Technical Bulletin 222

12.2021

Contents

1. Purge valve
2. Fuel tank drain hose
3. Rear wheel speed sensor connector
4. Triumph shift assist connector

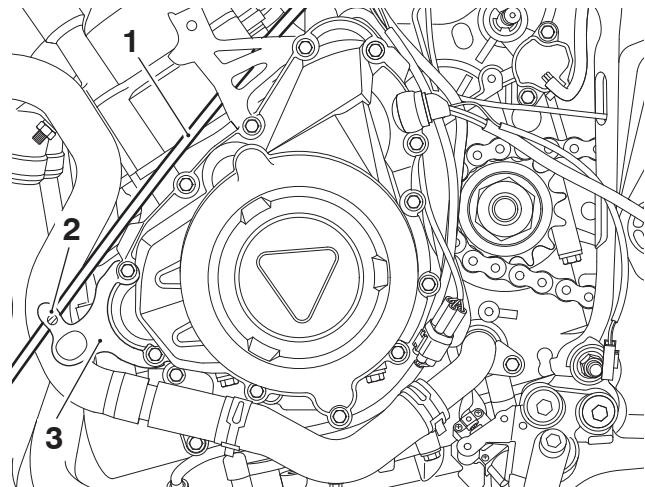
The routing for the fuel tank drain hose and evaporative vent hose has changed.

When installing the fuel tank drain hose, make sure it is routed above the Triumph Shift Assist and rear wheel speed sensor connectors, and below the purge valve as shown below.

1. **Fuel tank drain hose**
2. **Clip**
3. **Fairing bracket**

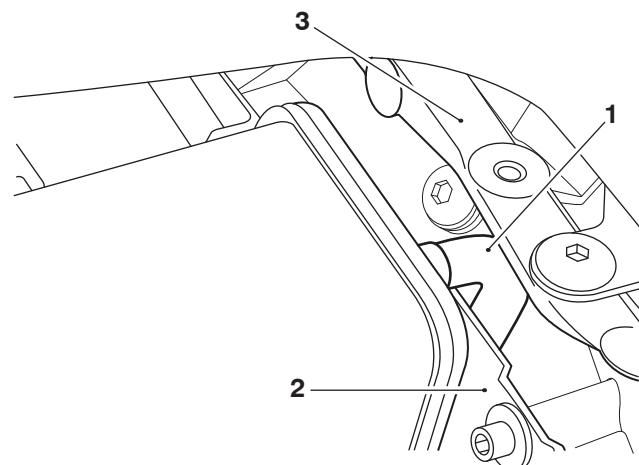
The fuel tank drain hose is then routed under the frame and on top of the left hand side engine cover, and secured by the clip at the rear of the lower left hand fairing bracket.

1. Damping adjuster
2. Lock washer
3. Screw

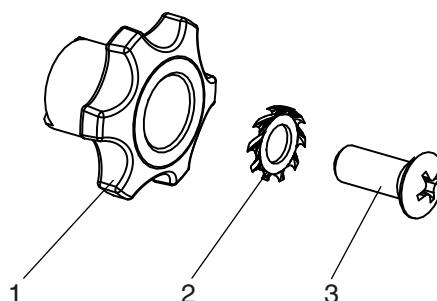
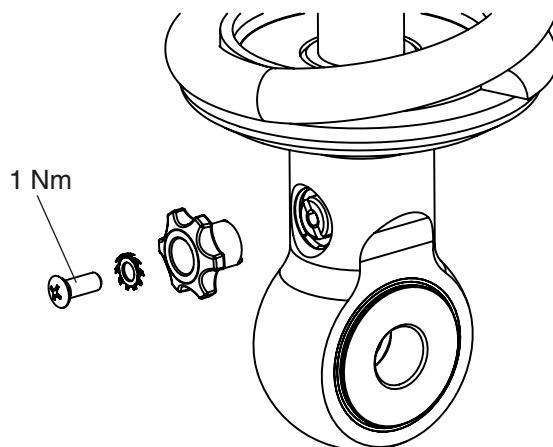
A rebound adjuster parts kit has been introduced for the above models.

Parts Kit T2051090 - Damping Adjuster Kit, RSU

When installing the new damping adjuster, make sure the lock washer is fitted and tighten the screw to **1 Nm**.

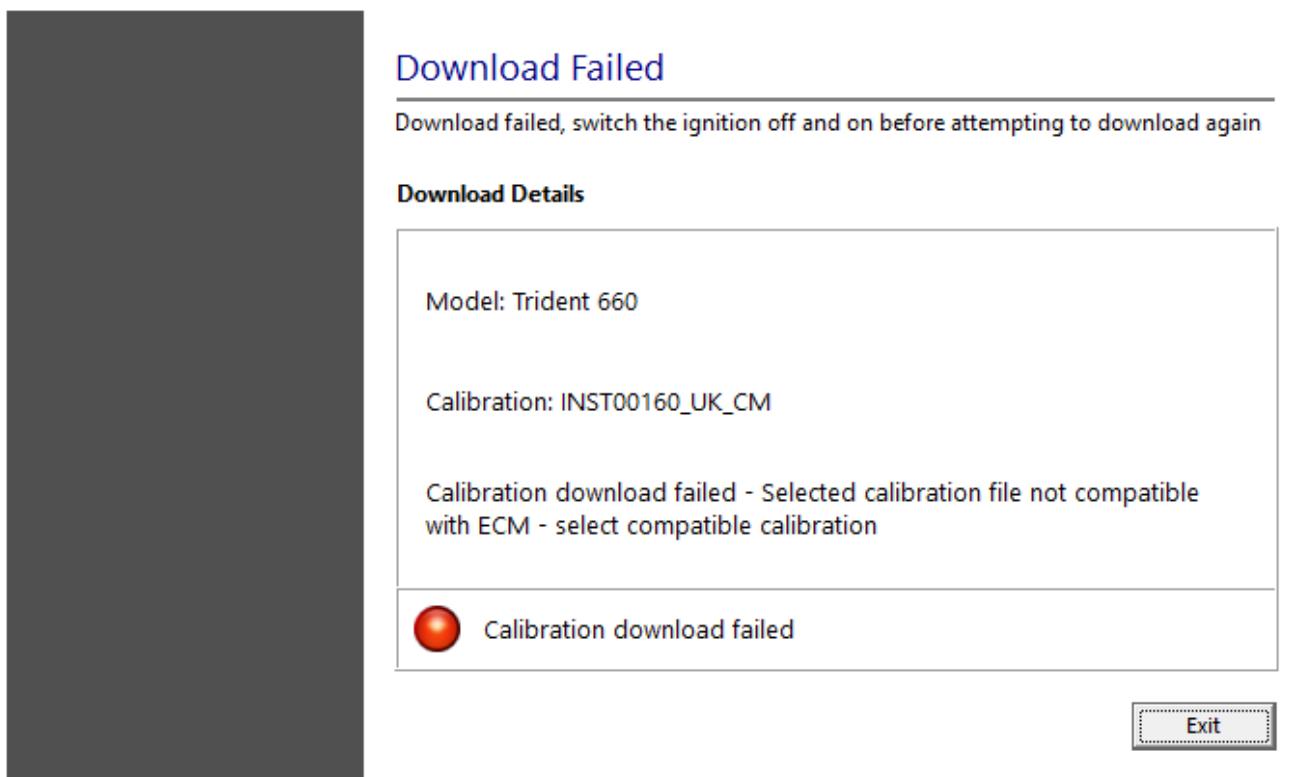
A new version of instrument hardware has been introduced for the above model.

The new instrument hardware version has dedicated calibrations that are not compatible with previous versions of the instrument hardware.

From version 2021-14.1, the diagnostic tool will only allow calibrations to be downloaded that are correct for the instrument hardware version detected. This works as follows for the Automatic and Manual download areas.

The diagnostic tool will automatically detect the instrument hardware version by reading the "Triumph Base Part Number" from the instruments upon motorcycle connection. When the tool progresses to the calibration selection menu, only calibrations that are appropriate for the model and instrument hardware version will be made available for download.

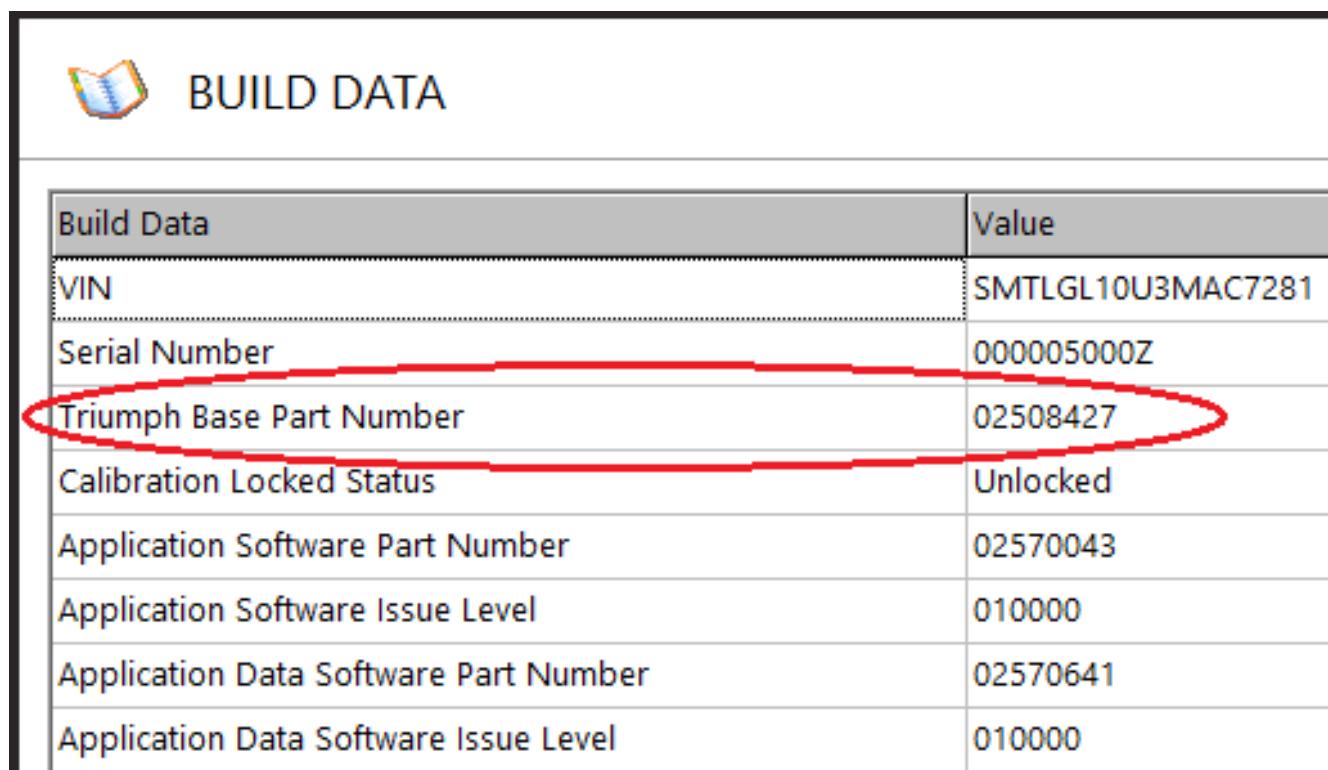
The instrument Triumph Base Part Number can be read from the instruments as follows:

1. From the Instrument Build Data screen provided in the Instrument Diagnostics area of the diagnostic tool.
